1435 - P045a

Entrance Hall//Existing//Plan_1:20

1435 - P253a

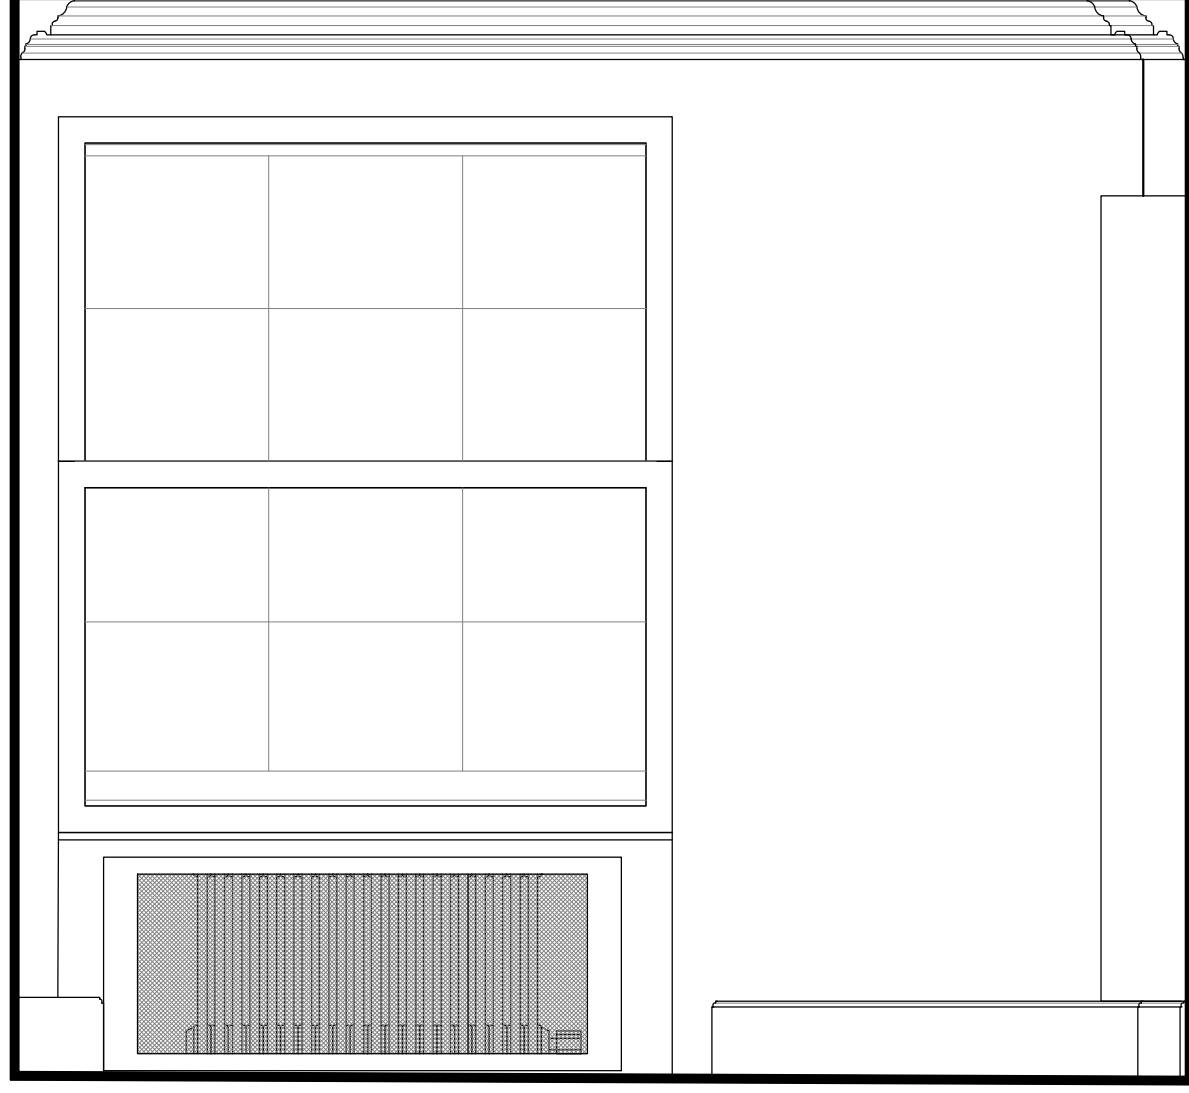
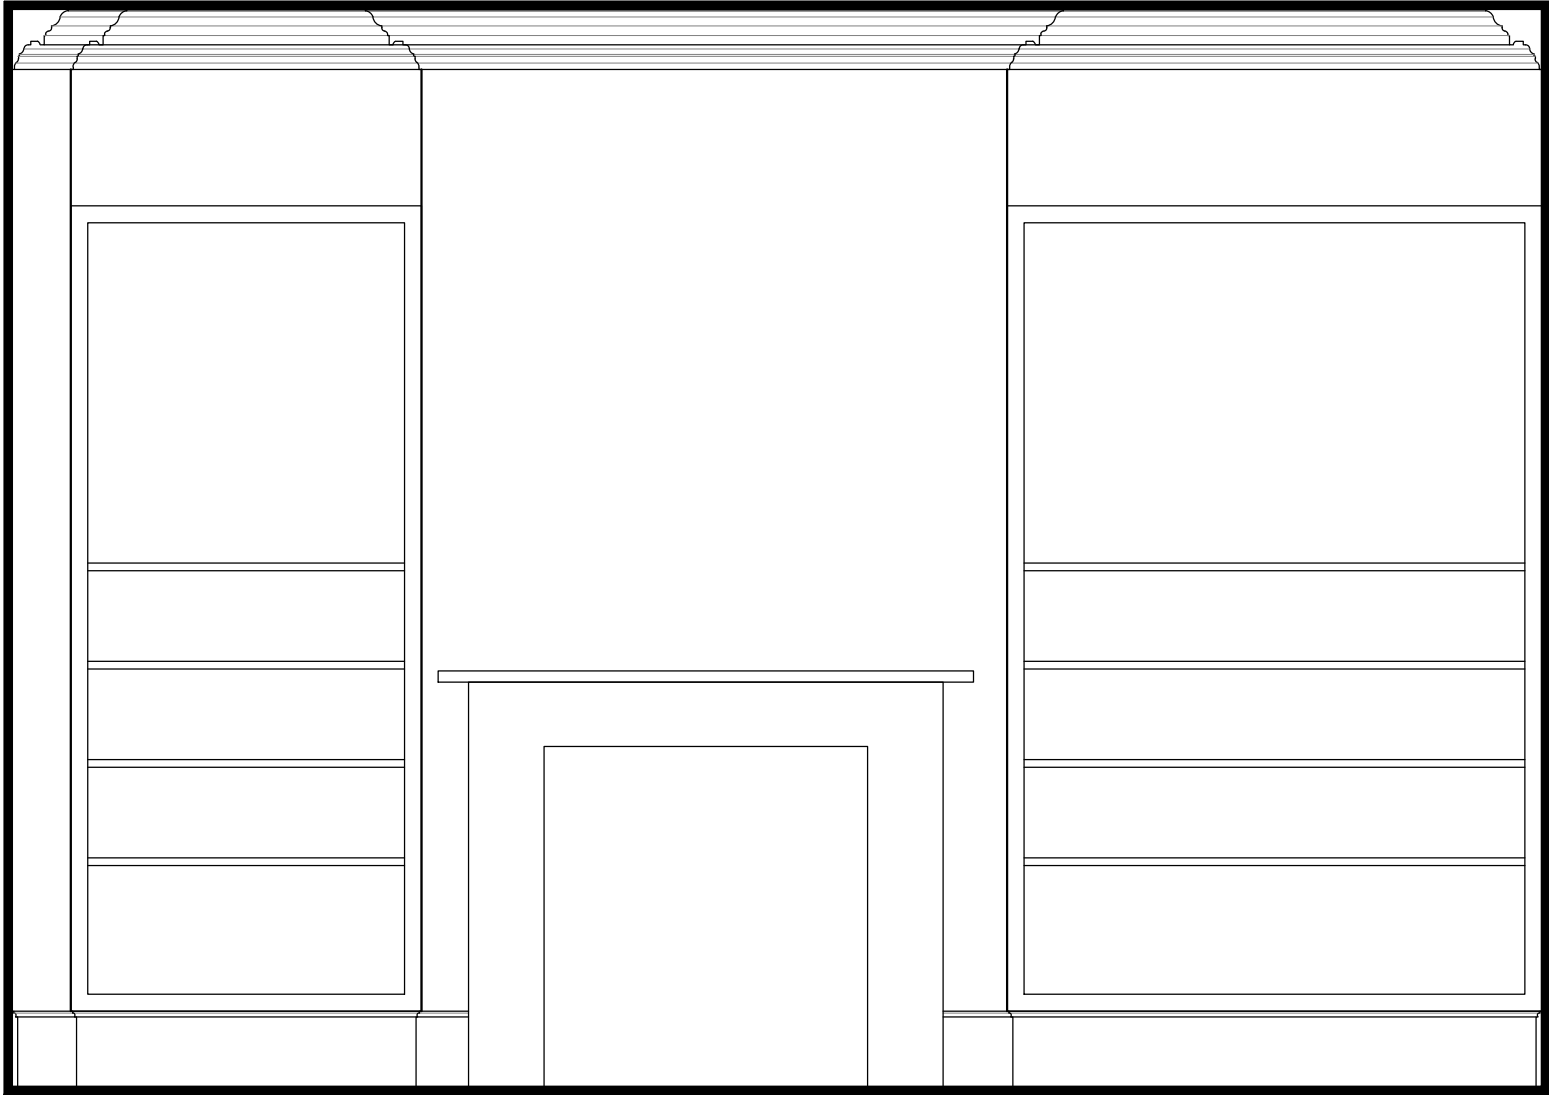
Existing single panel
double glazing removed
and replaced.

Proposed window
architrave.

Proposed sliding
shutters to window to
have panelling to
match walls. Shutter to
be full height.

Existing radiator
removed, opening
reformed and relined.
New column radiator.

Existing bookshelves
removed.

Stud wall form to allow
for recessed sliding
shutter to window.
Panelling proposed to
new studwork.

Rev	Date	Notes
A	23.06.15	Radiator added.

1435 - P054a

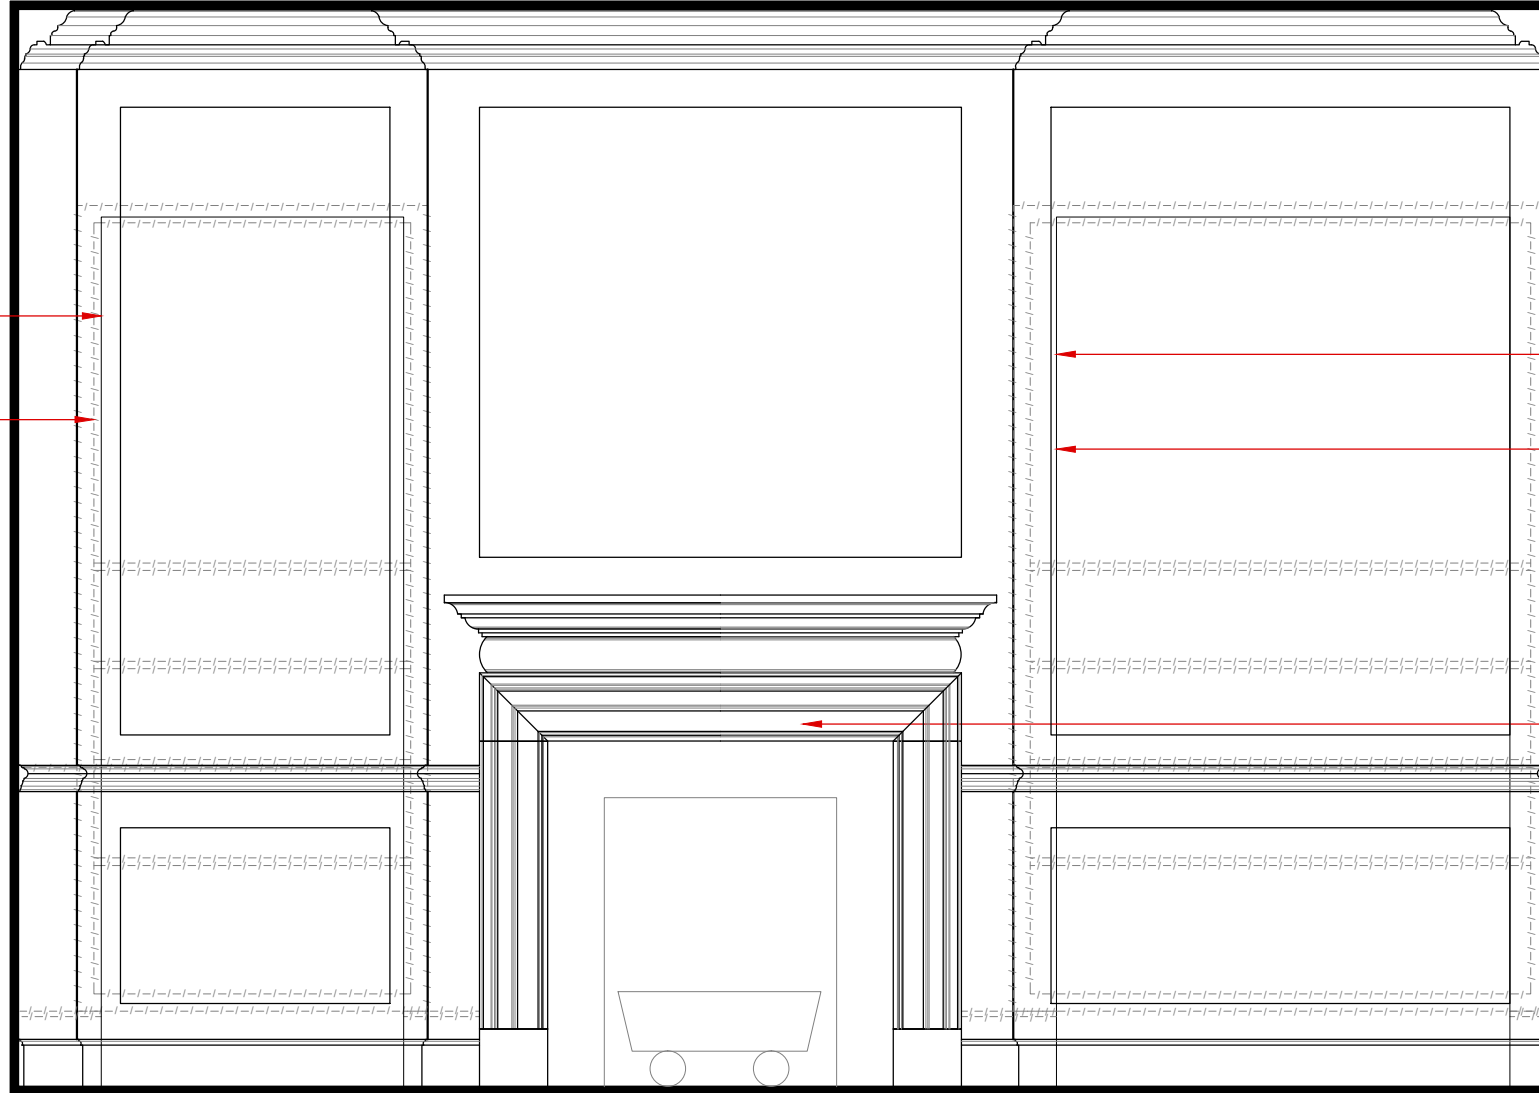
Rev	Date	Notes
A	14.05.15	Drawing revised to show existing fireplace following comments from council.

Proposed free standing unit.

Existing bookshelves removed.

Existing bookshelves removed.

Proposed free standing unit.

Reline flue, and add new surround and heath.

1435 - P055

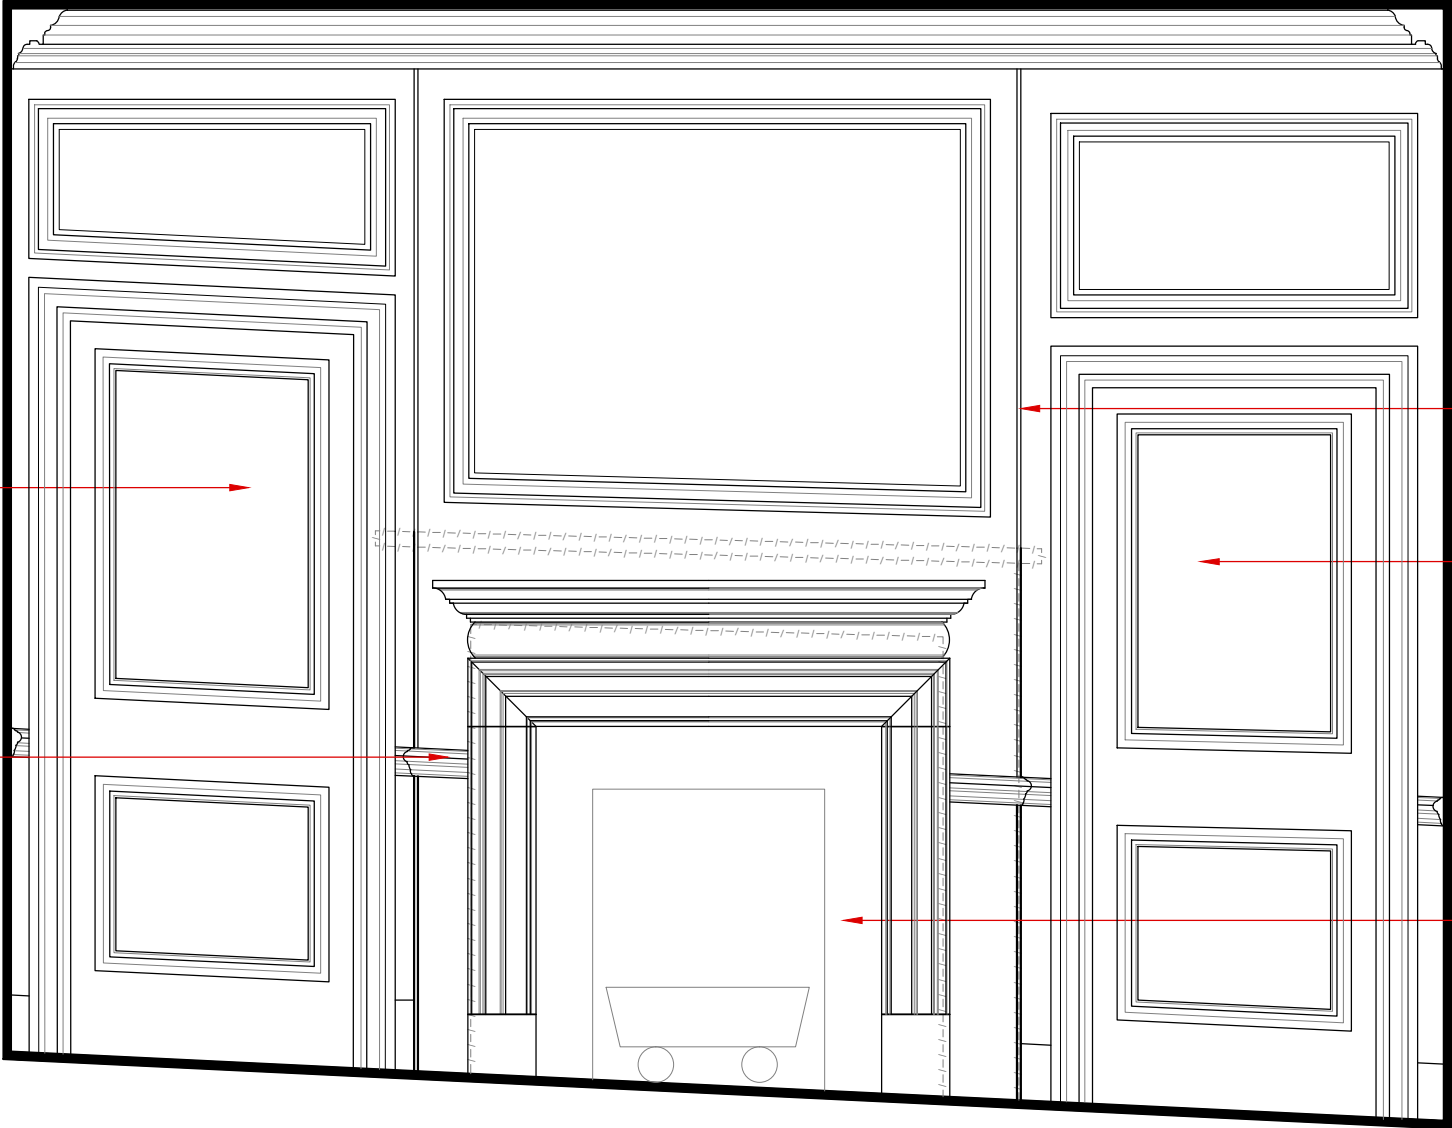
Proposed 2 panel door to match D.G.06.

Proposed moulding to match existing.

Dowel to corner.

Remove existing non-original fitted bookcase and reinstate panelling to studwall. Panelling to indicate existing opening through to rear room.

Reduce opening and remove non-original hearth. Render inside, reline flue and fit new surround and hearth

Rev	Date	Notes
A	14.05.15	Panelling revised to show door locations following comments from council.

1435 - P057

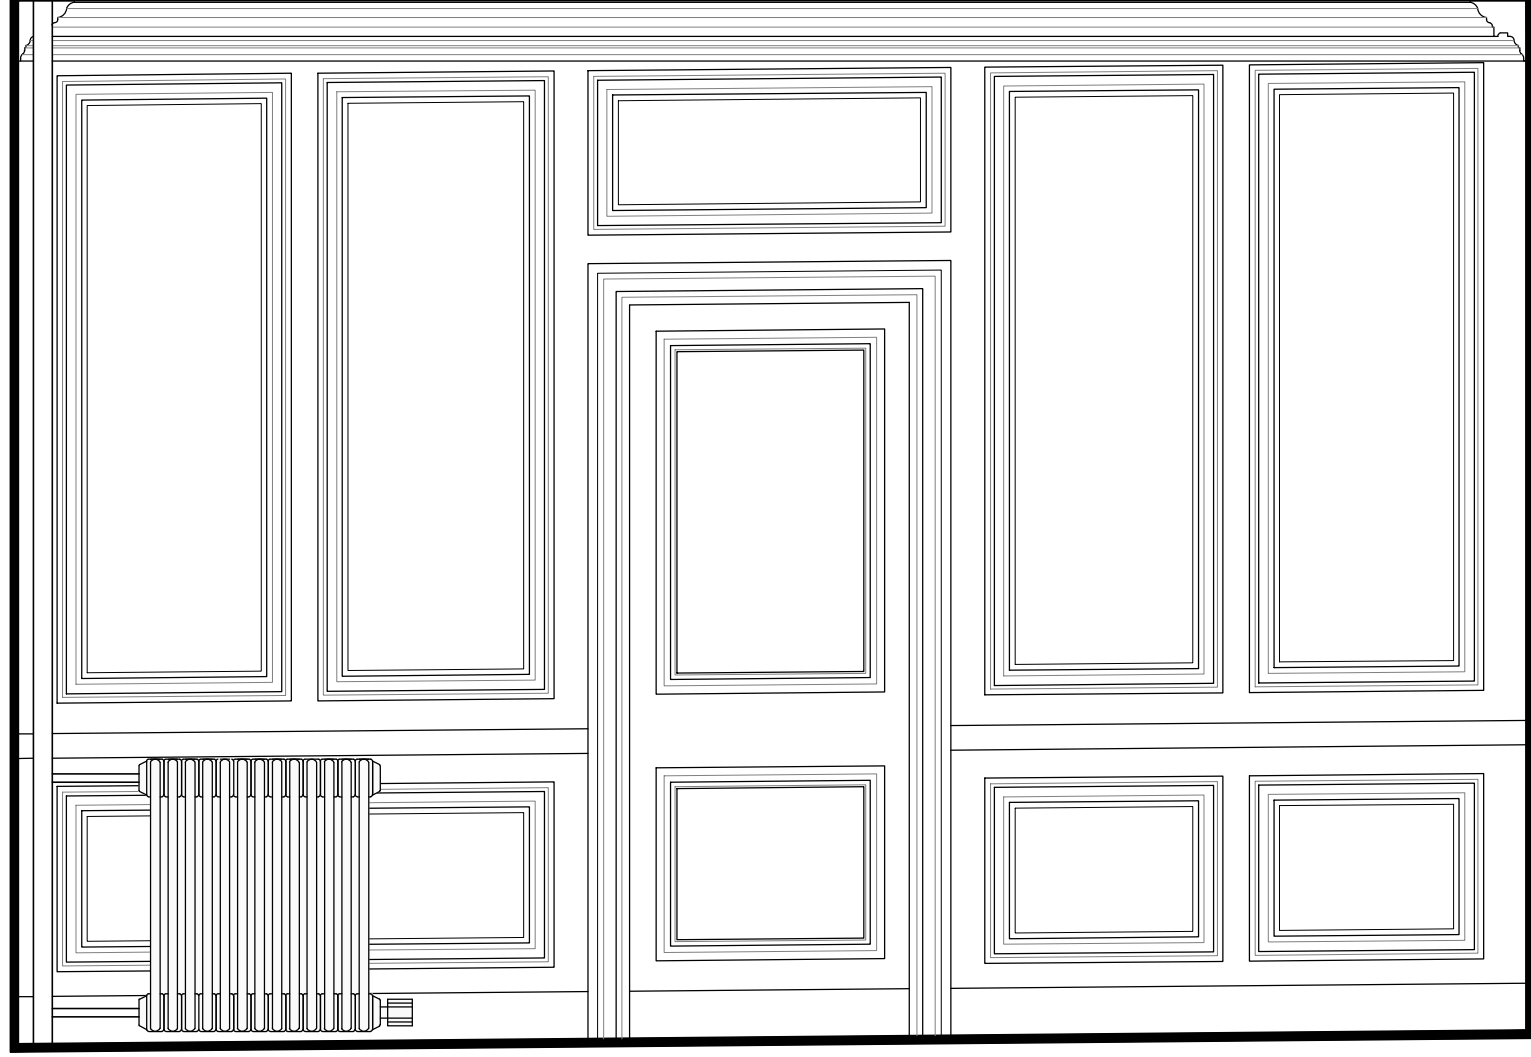
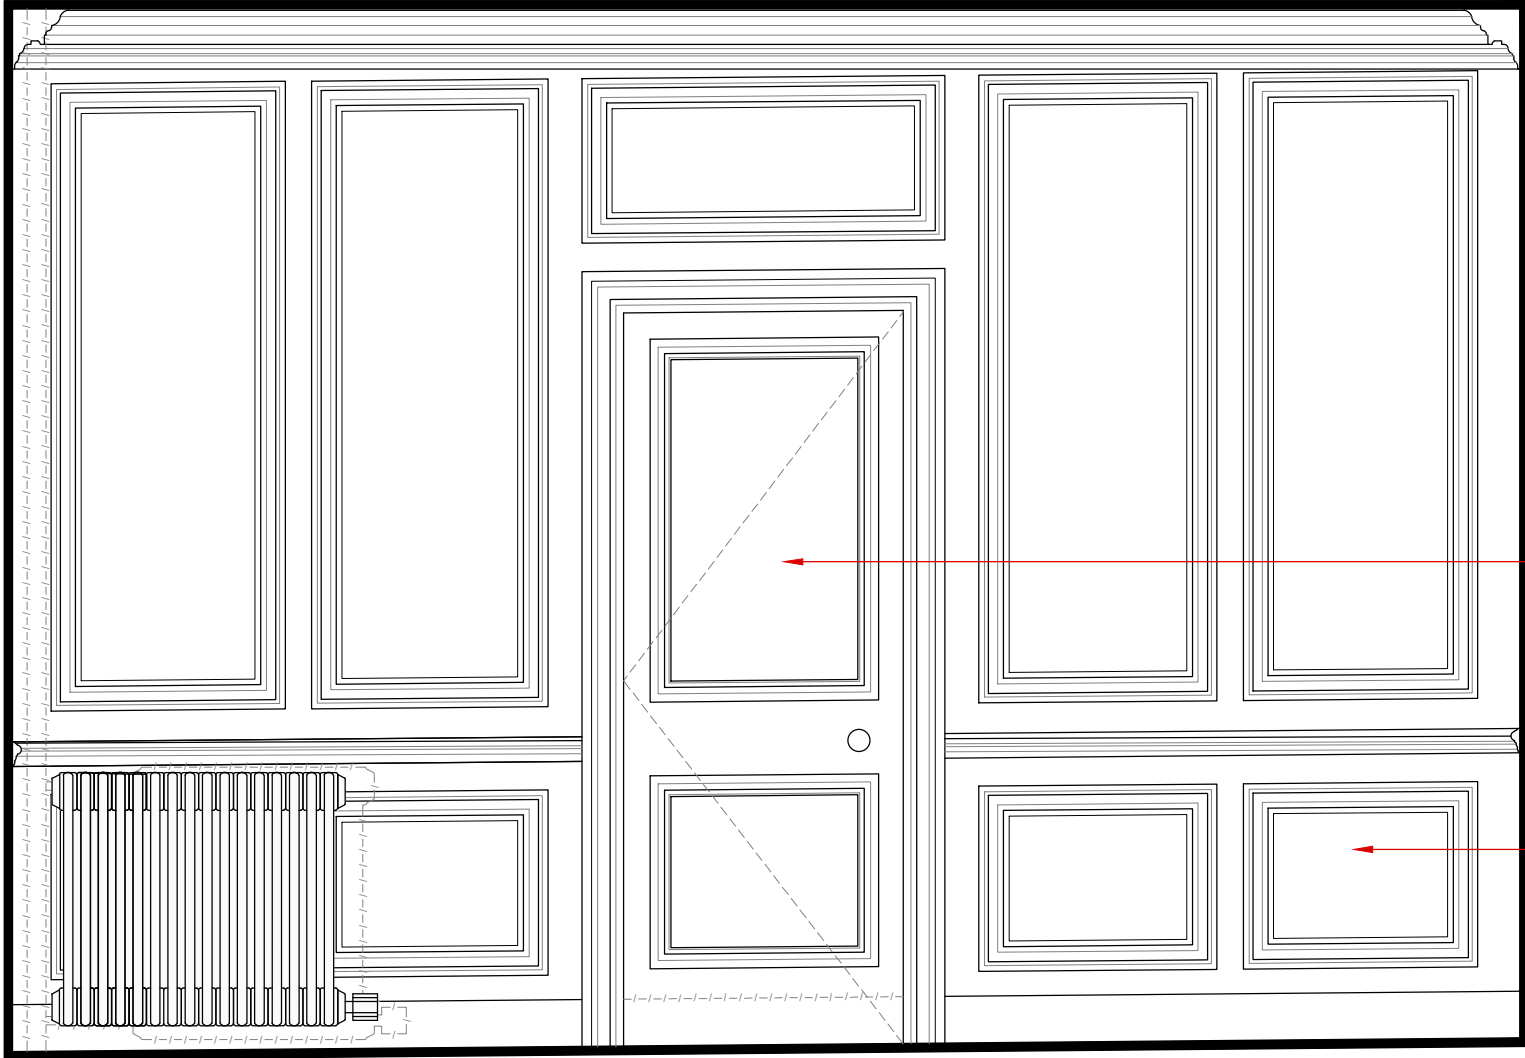
Existing panelling retained.

Existing shutters to windows to be reinstated to work with secondary glazing.

Existing fixed door to be re-hinged to be reused as doorway.

Existing panelling retained.

Rev	Date	Notes
A	23.06.15	Radiator added.
